Minutes of Meeting
Perkasie Planning Commission
June 24, 2026

505 Constitution Avenue – Recycling Facility (Land Development Application)

PRELIMINARY SUBDIVISION AND
LAND DEVELOPMENT PLAN
FOR
PERKASIE PLACE RECYCLING CENTER

Reference: Preliminary Subdivision and Land Development Plans – Review #1
Perkasie Place Recycling Center
505 Constitution Avenue
TMP #33-009-001
Perkasie Borough, Bucks County, PA

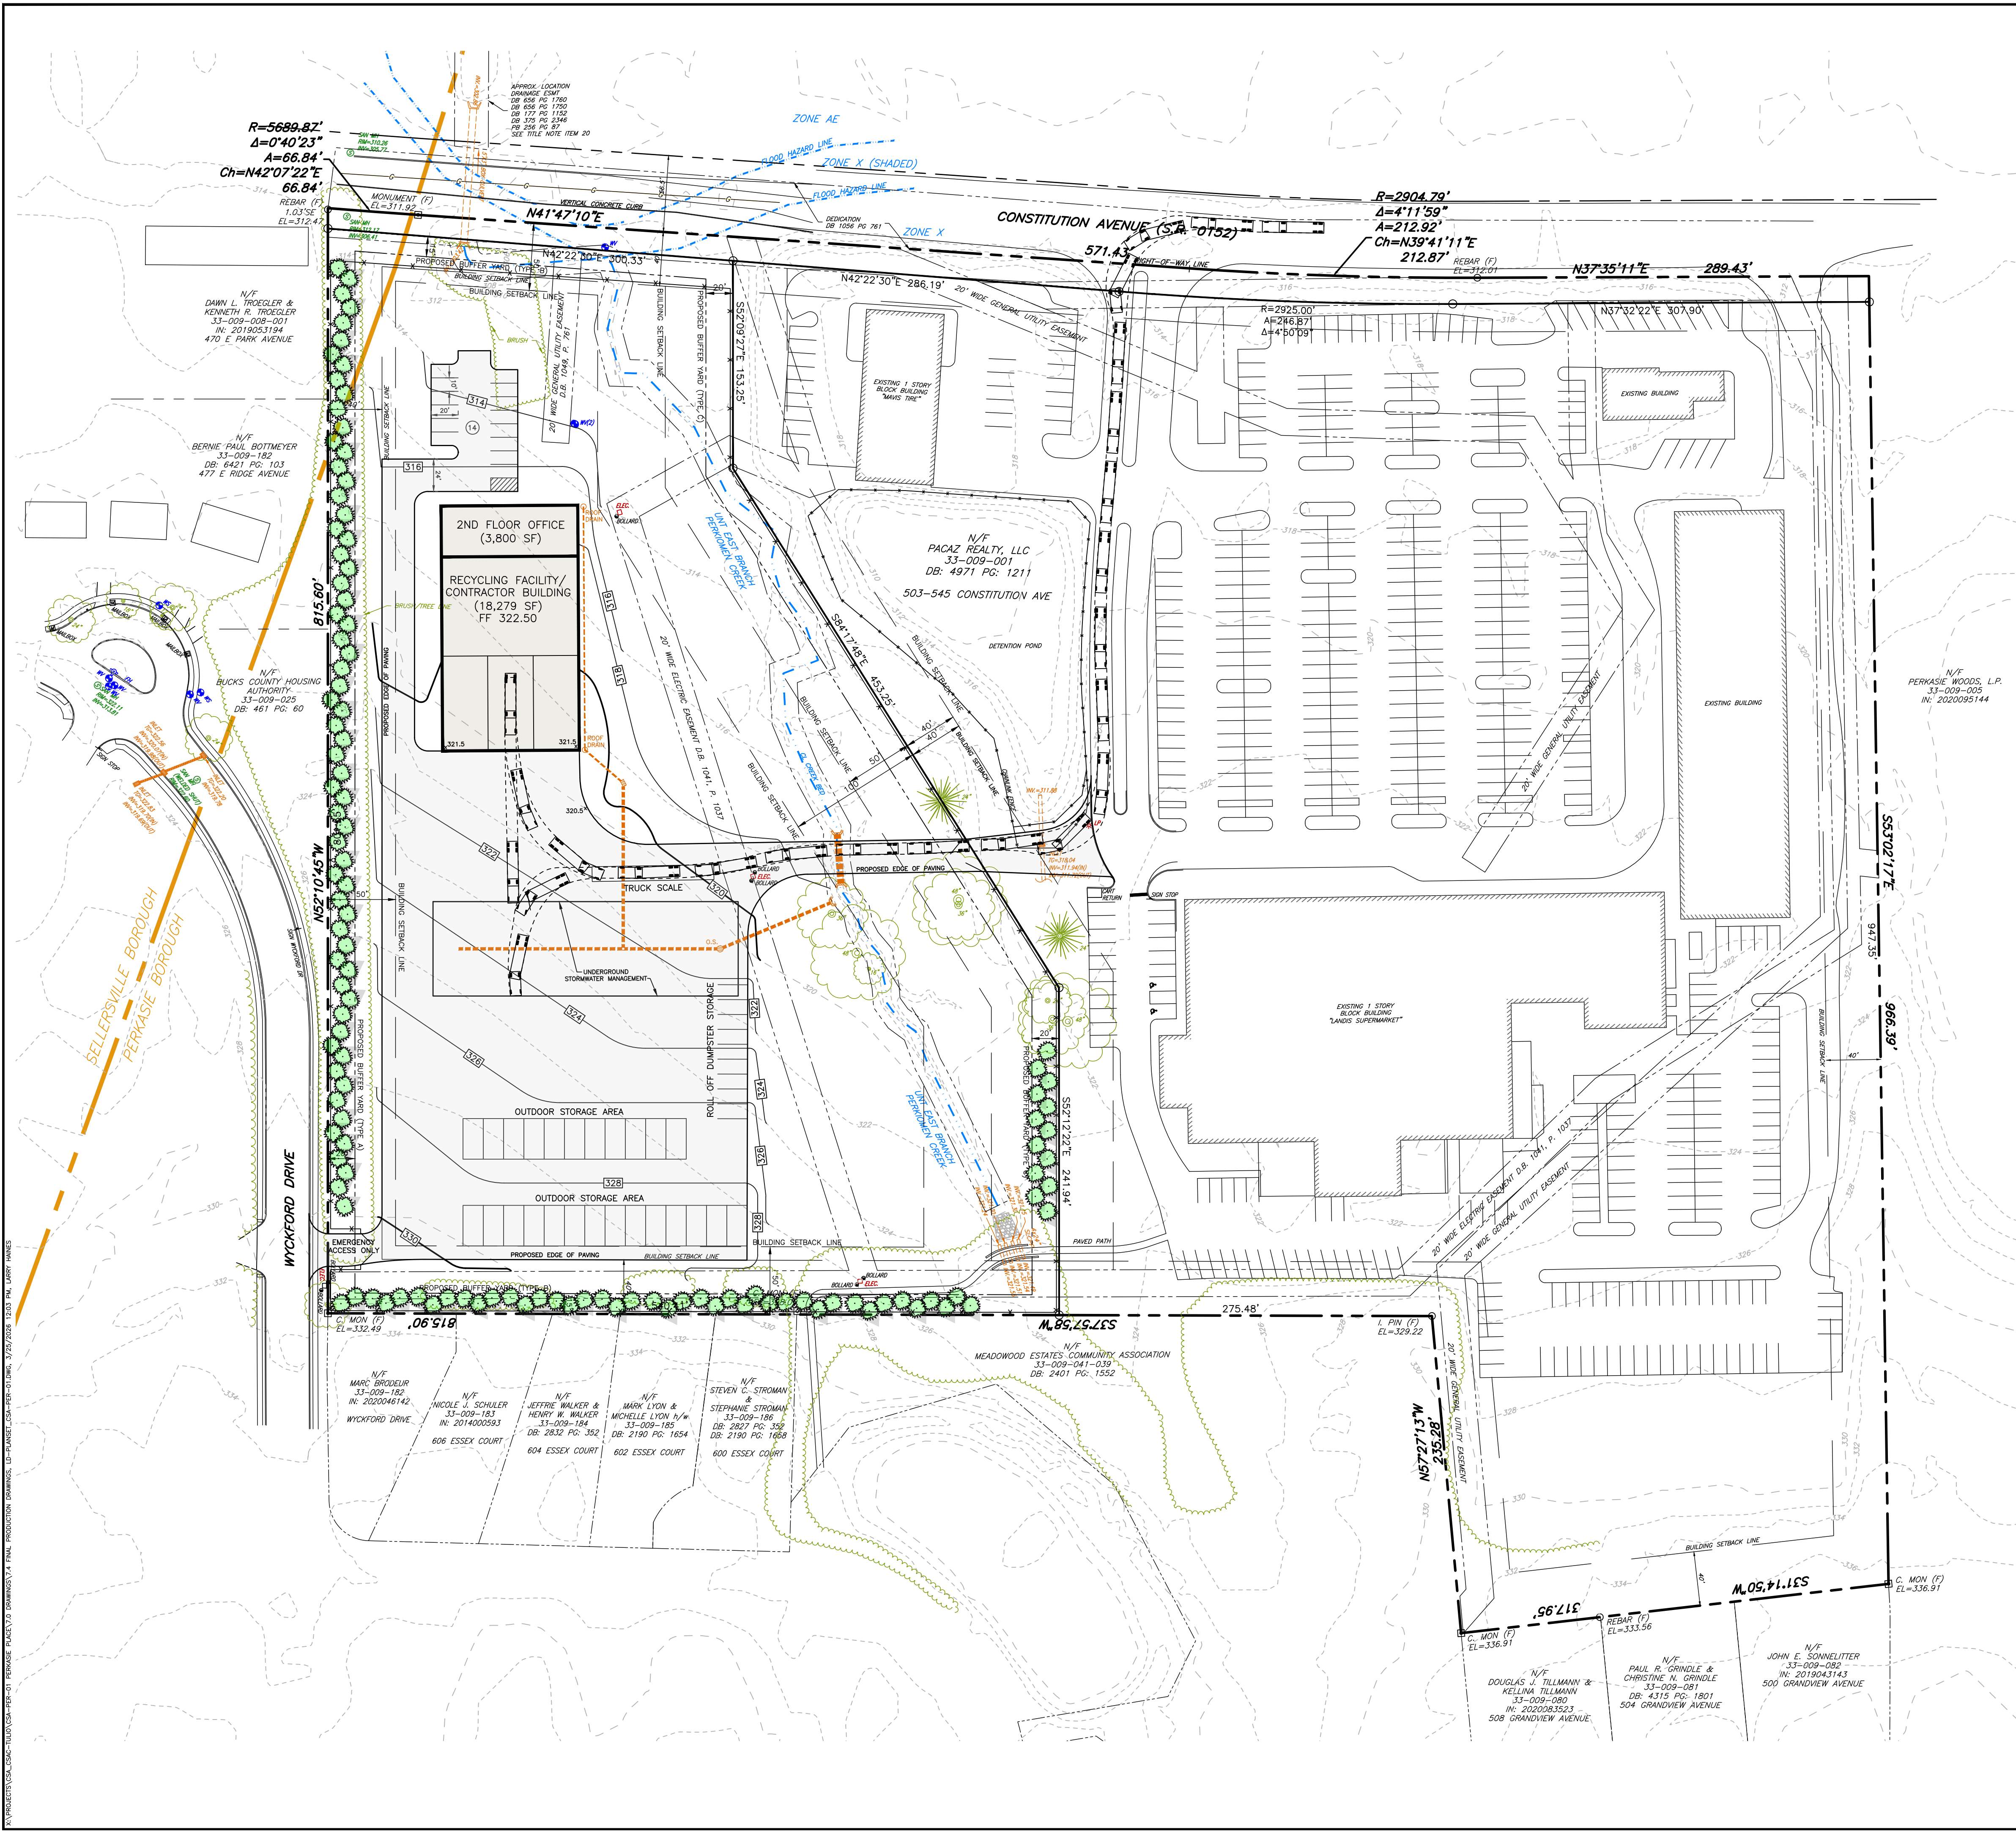
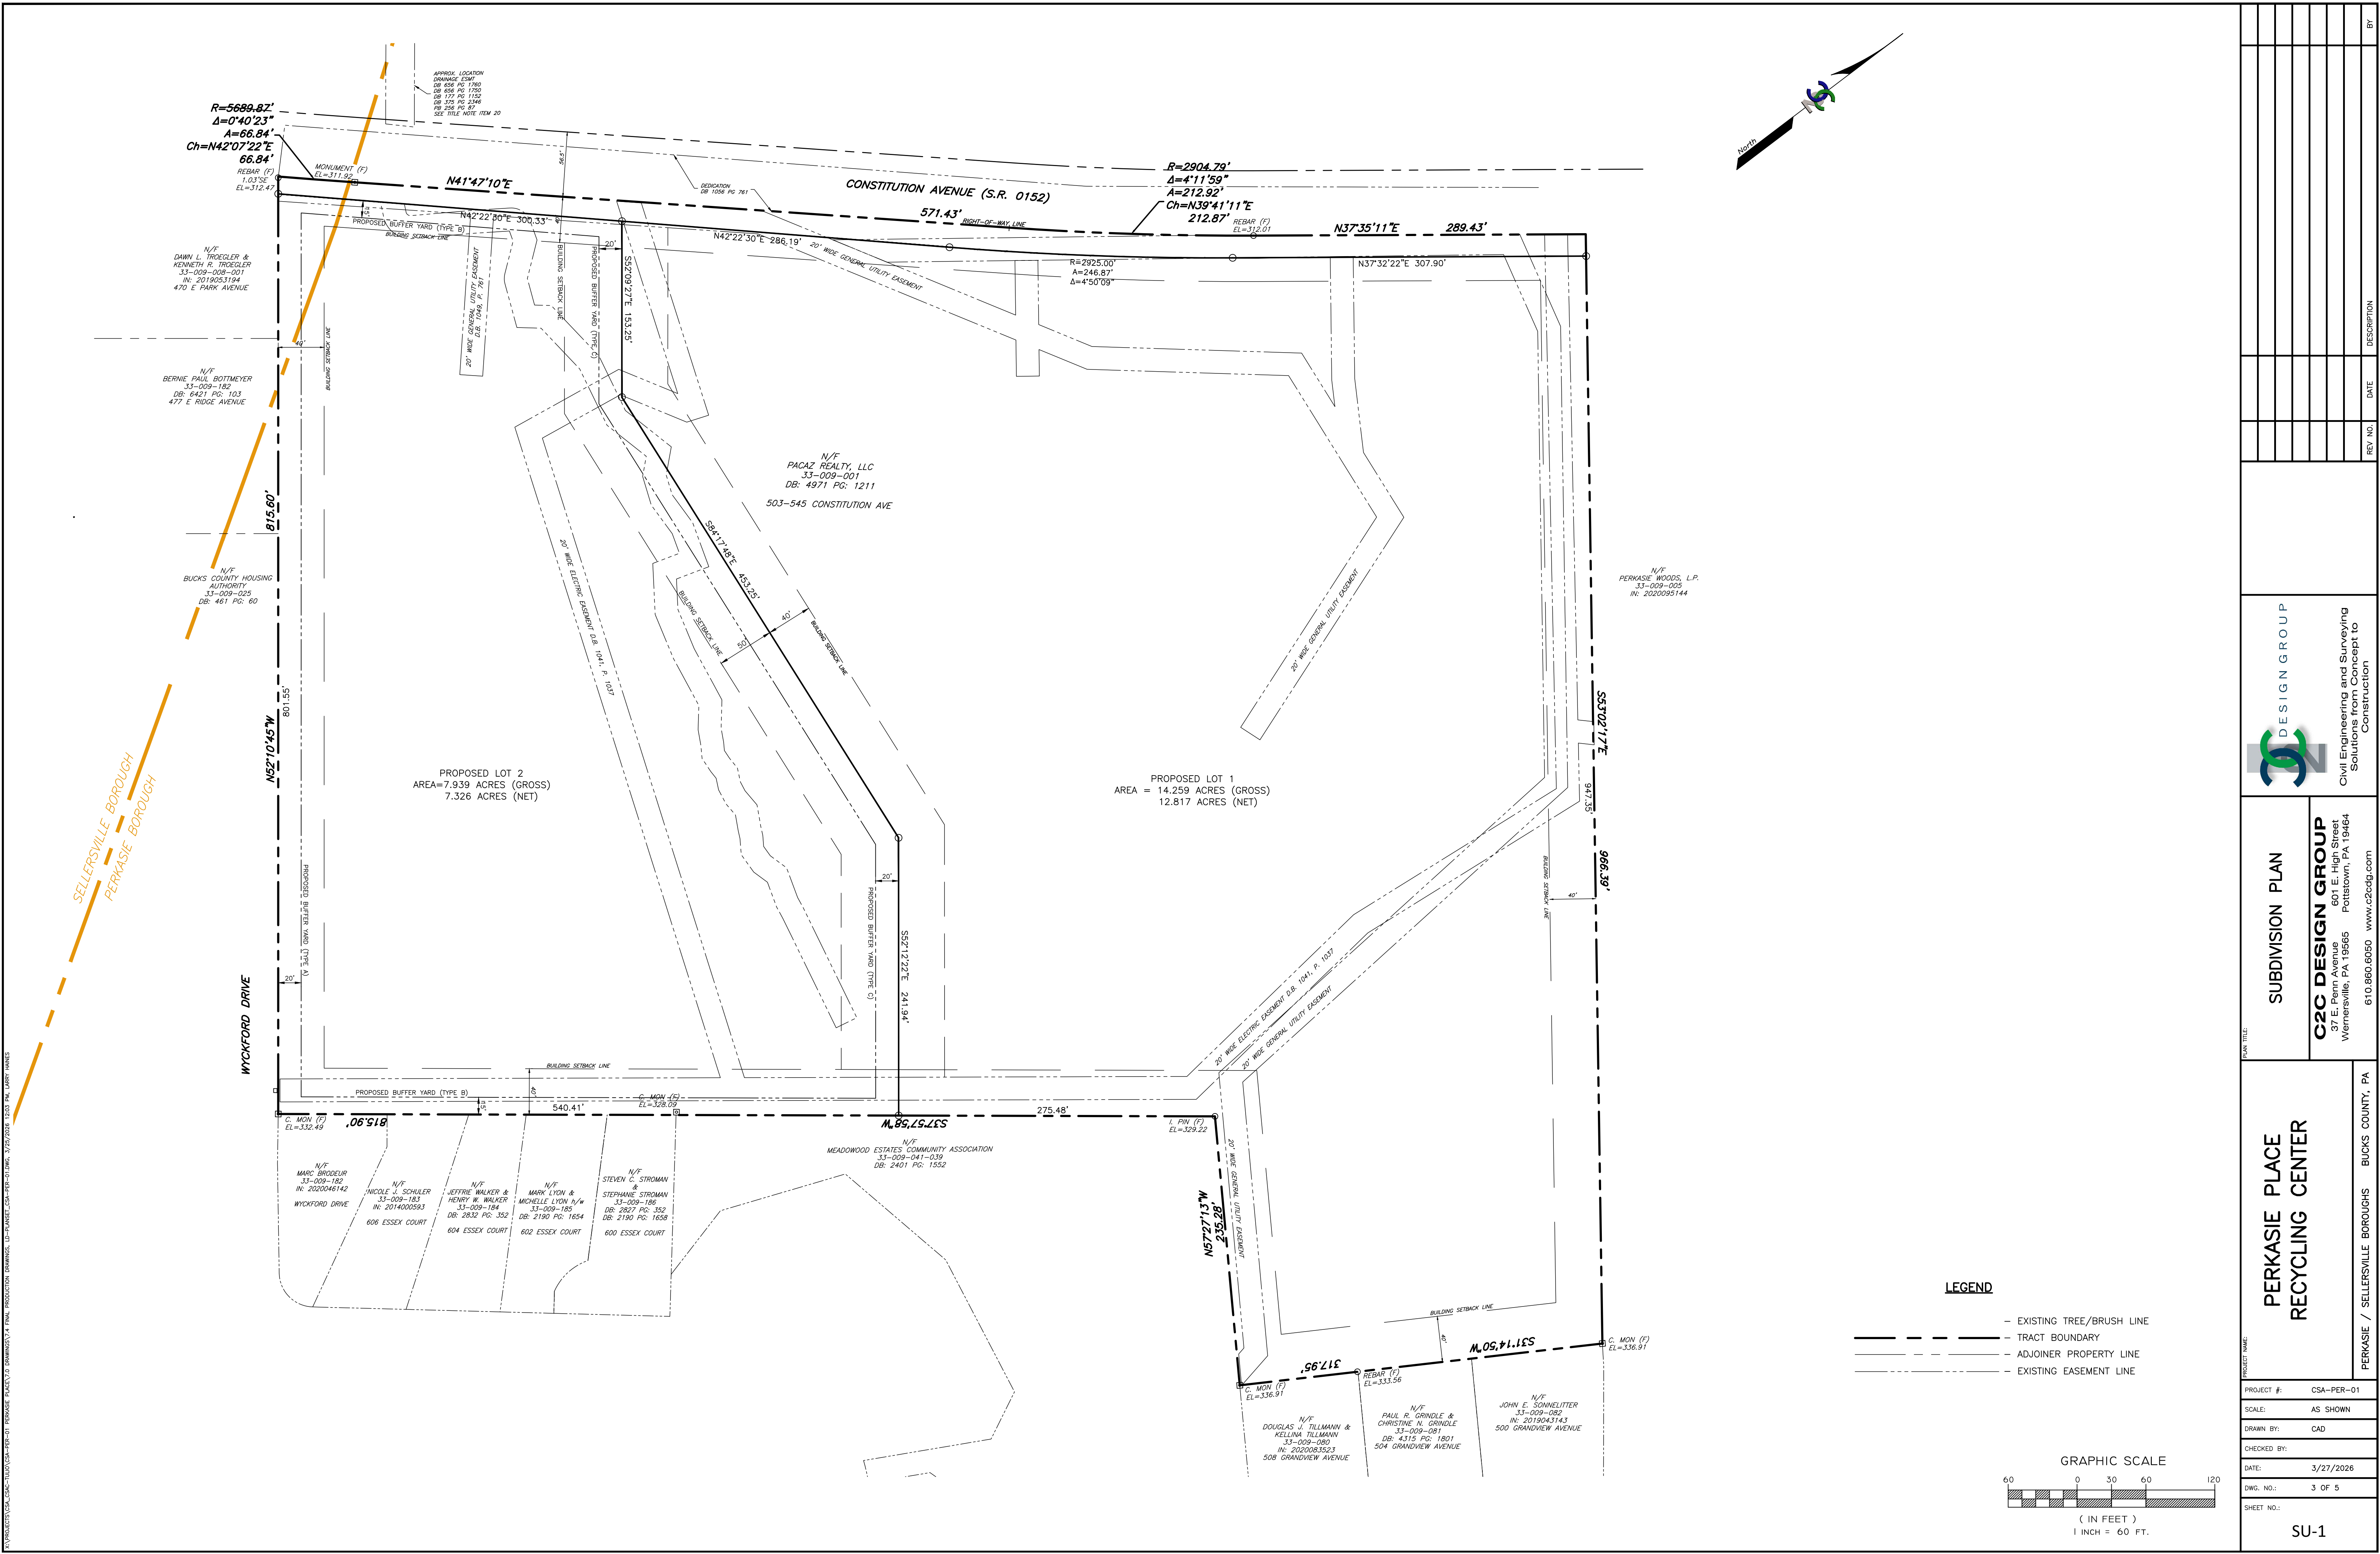
- 2. §186-18.G.(7)(b)[1] – A recycling facility use shall have a 100-foot front yard setback. The plans show a 50-foot front yard setback from Constitution Avenue and should be revised to show a 100-foot front yard setback. Also, the proposed building setbacks should be dimensioned on the plan.

- iv. The fence is shown crossing the access road to the recycling facility at an angle and should be revised to be perpendicular to the access road.
 - v. Details of the gates should be provided, including notation and specifications on how the gates can be accessed by emergency personnel and utility companies.

- i. §186-18.G.(9)(p) - Waste from the resource recovery facility process shall be located at least 100 feet from any property line and stored in leakproof and vectorproof containers. We note that the recycling facility building is 85 feet from the southern property line and the outdoor storage area is 50 feet from the eastern property line. The location of waste storage will need to be clarified, and notes added to the Record Plan identifying the locations prohibited from waste storage.

- j. §186-18.G.(9)(q) - A dense evergreen buffer shall be provided on the outside perimeter of the fenced area. Evergreens shall be four to five feet in height and planted on ten-foot staggered centers. The plans show the fence along the perimeter of the Lot 2 property line with landscaping along the interior of the fence. The fence should be relocated, and the evergreen buffer should be provided along the exterior of the fence line. Also, the buffer requirements of §186-54 of this chapter shall be met.

8. §186-45.B. - Based on the Borough’s Street Classification Map, Constitution Avenue is classified as an arterial street with a half-width right-of-way of 50 feet. The legal right-of-way appears to be 56.5 feet along the property frontage. Therefore, an ultimate right-of-way of 50 feet measured from the center line of Constitution Avenue should be shown on the plan. All zoning information, including setbacks, lot areas, lot coverage, etc., should be calculated based on the ultimate right-of-way.

18. §186-61.C. – The plan lists the parking requirements for a recycling facility of 3 spaces per 1,000 square feet of office floor area for a total of 12 required parking spaces. However, we note that the proposed building is labeled as Recycling Facility/ Contractor Building. The parking requirement for a “Contractor” use is 0.9 per 1,000 square feet of GFA, which would require an additional 17 spaces. Also, the plan notes a second floor office area of 3,800 square feet which requires 1 space per 350 square feet of GFA for an additional 11 required parking spaces for a maximum total of 28 required parking spaces. The proposed layout currently provides for only 14 spaces. The square footage allocated to each proposed use shall be clarified and the additional parking spaces provided.

19. §186-70.F – Parking lots with 90° parking should have 24-foot aisles for two-way traffic. We note that the outdoor storage area and roll off dumpster storage areas are laid out like a parking lot and should meet these requirements. The aisle between the outdoor storage area and roll off dumpster storage area is less than 24 feet. Also, the aisle on the southern side of the second row of outdoor storage area has a width of only 10 feet. Circulation exhibits should be provided to clarify how these spaces will be accessed to determine if additional spaces are required.

4. §164-24.D. – The proposed driveway connection to the shopping center should meet the minimum design requirements for a Class D driveway. The driveway width, radius and grades should be noted on the plan to demonstrate compliance with the requirement.

7. §164-25.A.(1)(f) – The edge of any parking area or parking driveway shall not be closer than 15 feet to the outside wall of the nearest building. This area shall be used for foundation plantings and sidewalks to entryways. The northwestern side of the proposed building is less than 15 feet from the parking and driveway aisle and should be revised to provide the required separation. Also, the distance between the building and the parking area/driveway should be dimensioned on the plans.

11. §164-30.F – Lots excessively deep in relation to width or lots excessively irregular in shape are to be avoided. A proportion of 2½ in depth to one width is generally accepted as a proper maximum. Proposed Lot 2 has a width of 300 feet at the building setback line and a depth exceeding 750 feet. The proposed subdivision line should be revised to not exceed the 2½ to 1 ratio or a waiver required.

- b. The building notes a finished floor elevation of 322.50 which is 6.5 feet higher than the adjacent parking lot. The access door for the building should be shown on the plan and stairs and ramps to the access door should be shown on the plan with associated grading and spot elevations.

16. §164-32.C – Nothing should be permitted to be placed, planted, set or put within the area of an easement, the area should be kept as lawn. The proposed fence and access driveway are shown within existing easements and within a proposed easement. The fence and driveway should be relocated or a waiver requested from this requirement.
